FINAL DRAINAGE PLAN SF 21-00X

SF-21-010

THE HILLS AT LORSON RANCH FIL. 1

**PCD-ENGINEERING REVIEW COMMENTS
IN BLUE BOXES WITH BLUE TEXT**

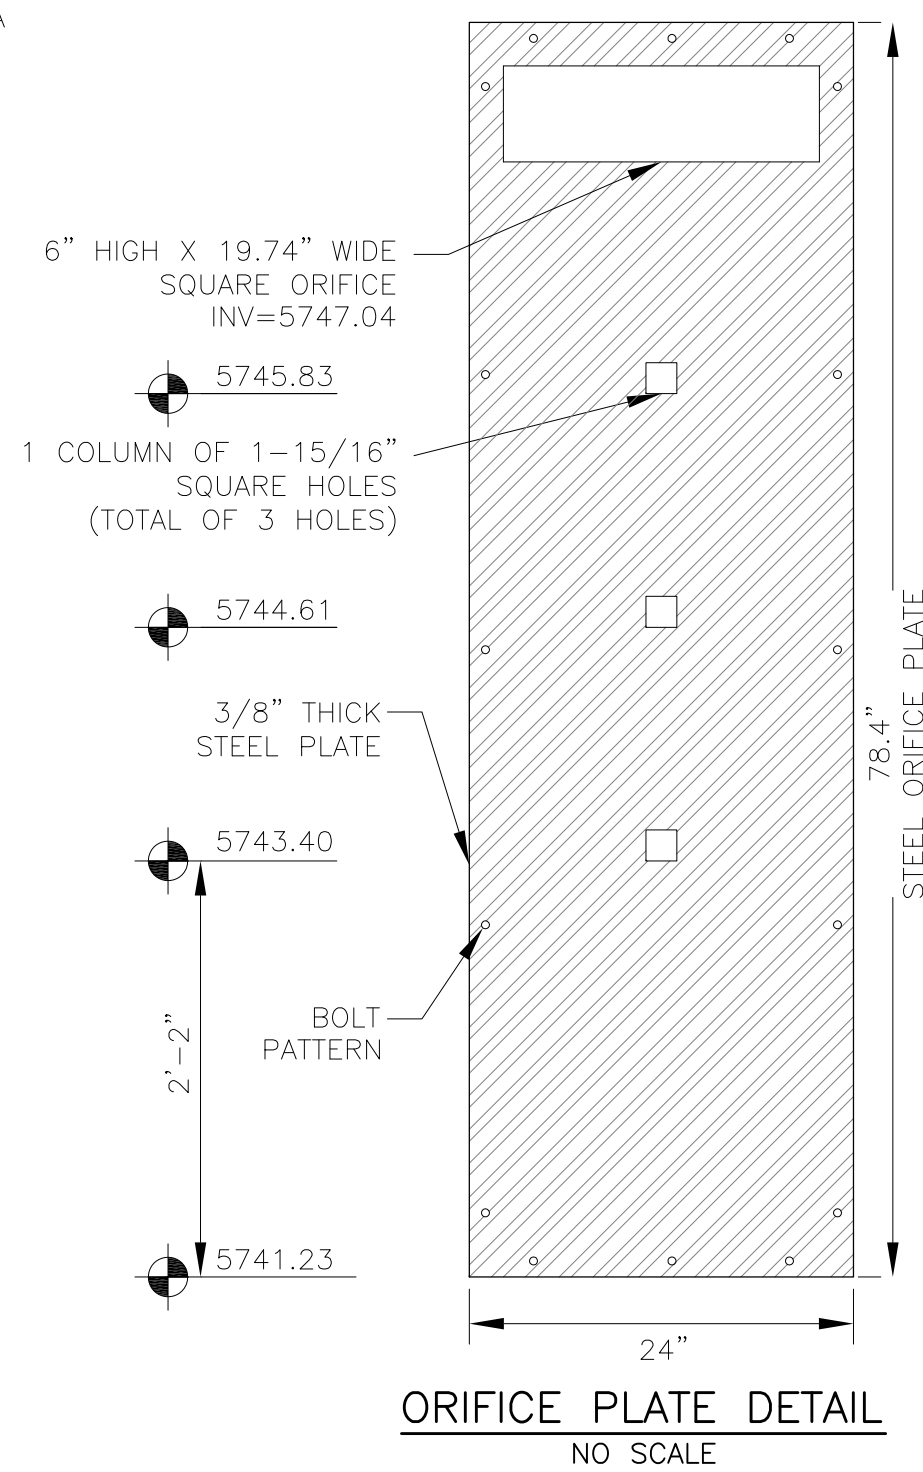
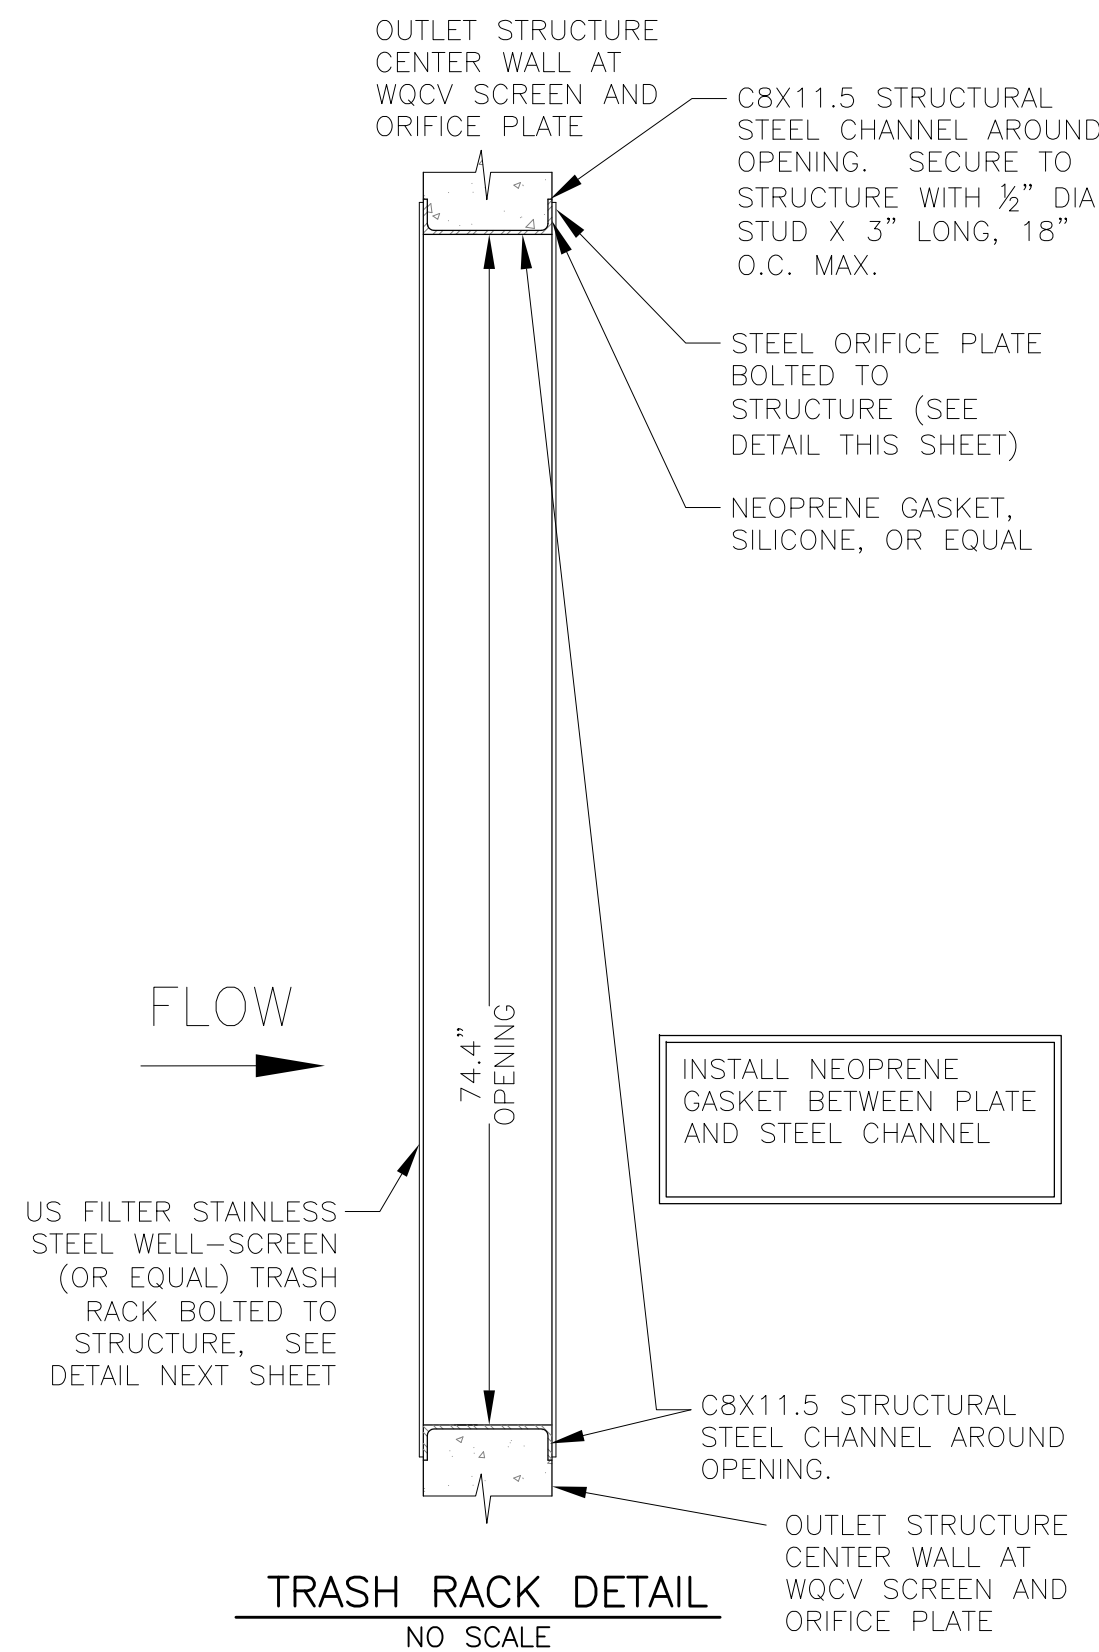
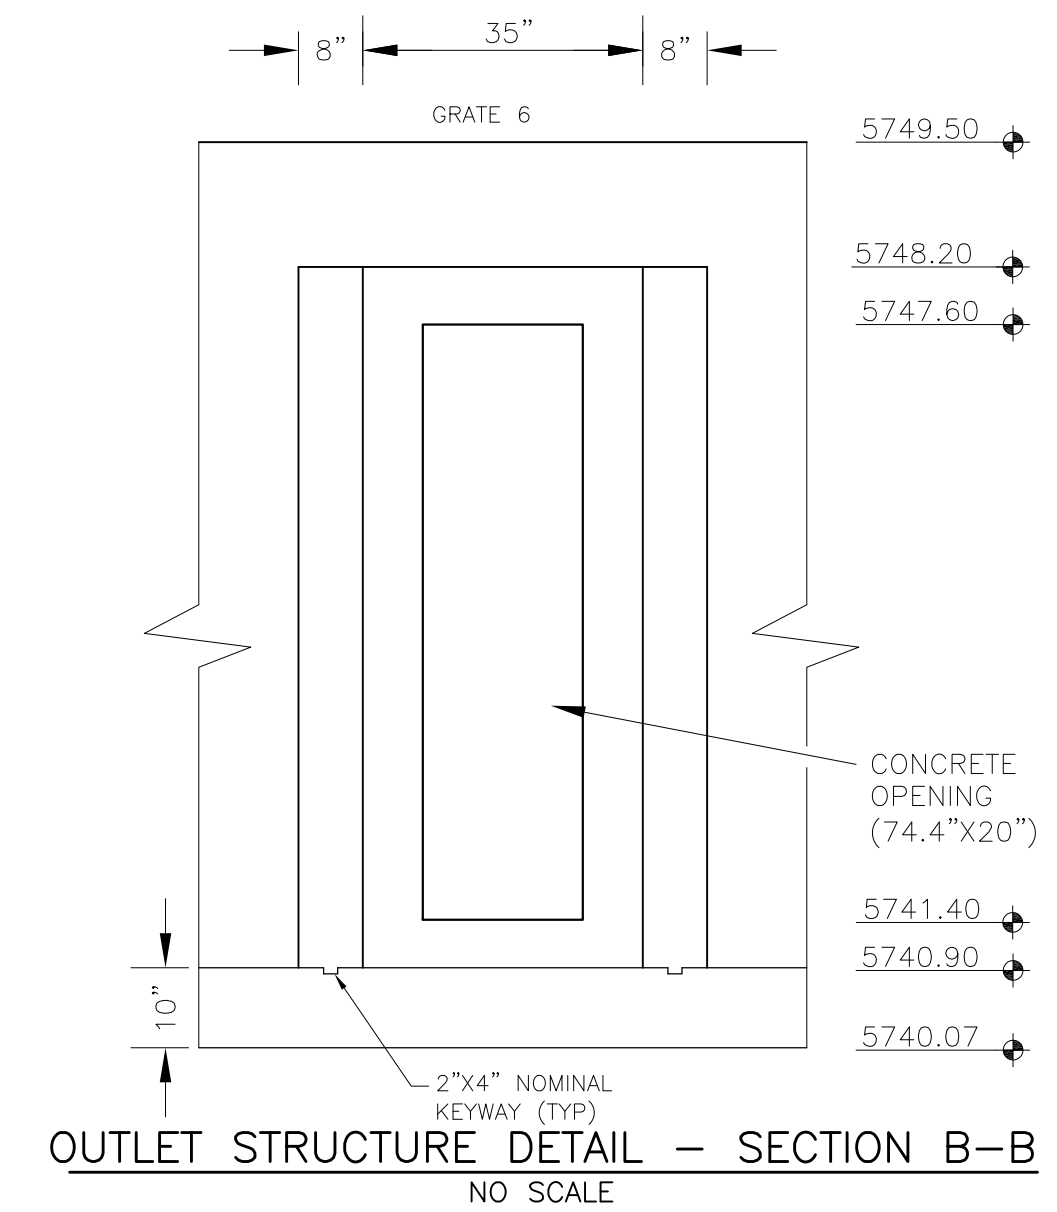
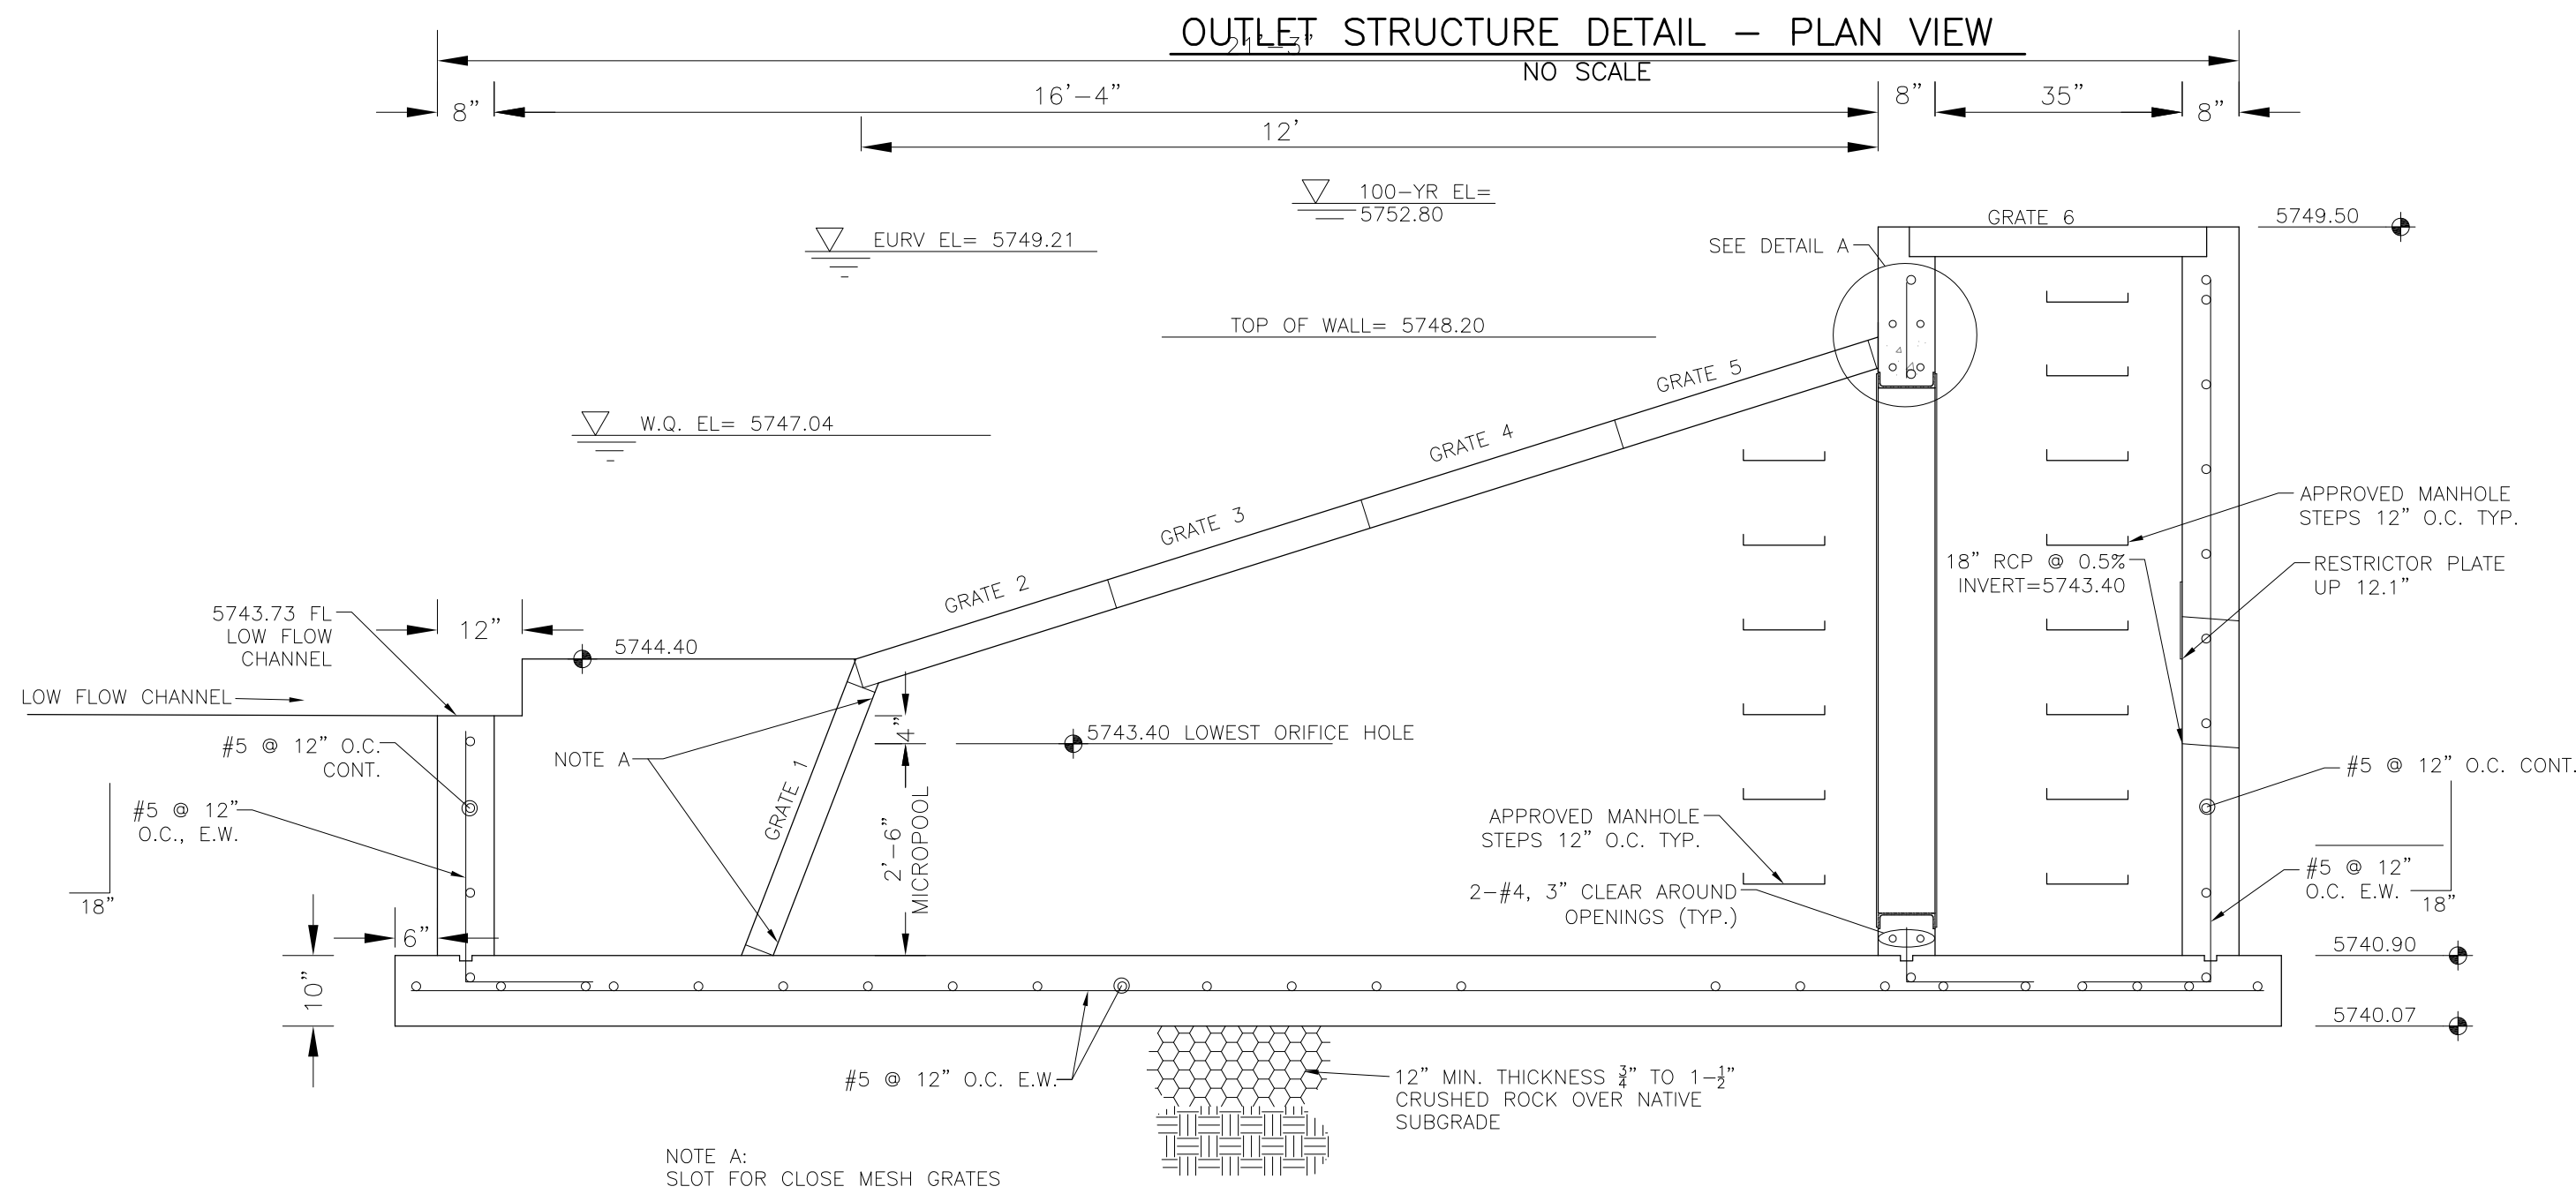
Include these pond details in the GEC Plan.
